# **FORD** PERFORMANCE

## **Technical Service Bulletin – 41**

### **Mustang Dark Horse R CAN Bridge Update**

Figure (B): *Center & Forward of Instrument Panel*

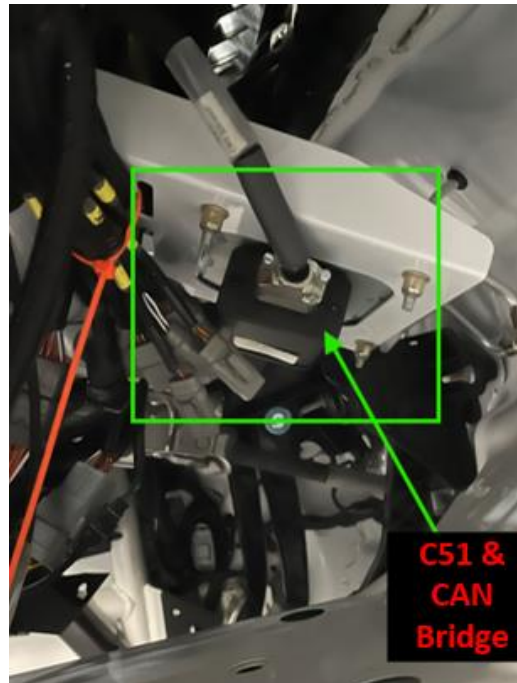
Disconnect connectors and ground connection identified in Figures (B-E), carefully cut tie straps securing harness in vehicle, and remove CAN bridge & harness from vehicle. Set aside.

Figure (F)

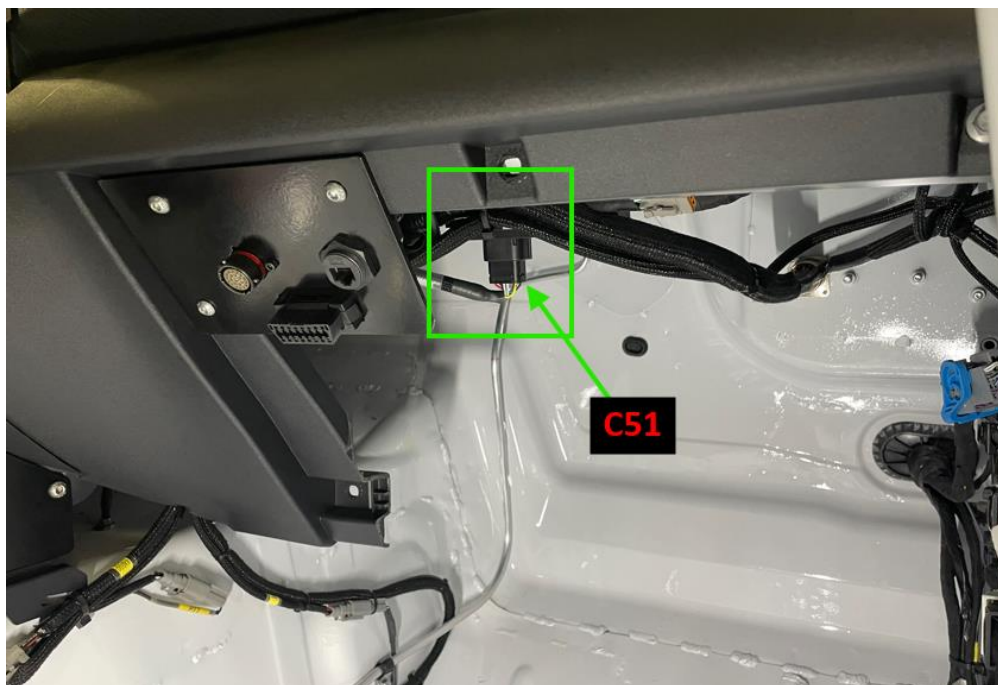
***NOTE: Mounting location of new CAN bridge & C51 is different from the CAN bridge removed from vehicle. See Figures (F & G) below.***

Install *new* CAN bridge & harness in vehicle by performing removal procedure in reverse order. Secure harness with tie straps minimum of every 300 mm (11.8 inches). Secure CAN bridge with tie straps to roll bar behind glove box opening (right side of instrument panel) as illustrated in Figures (F & G).
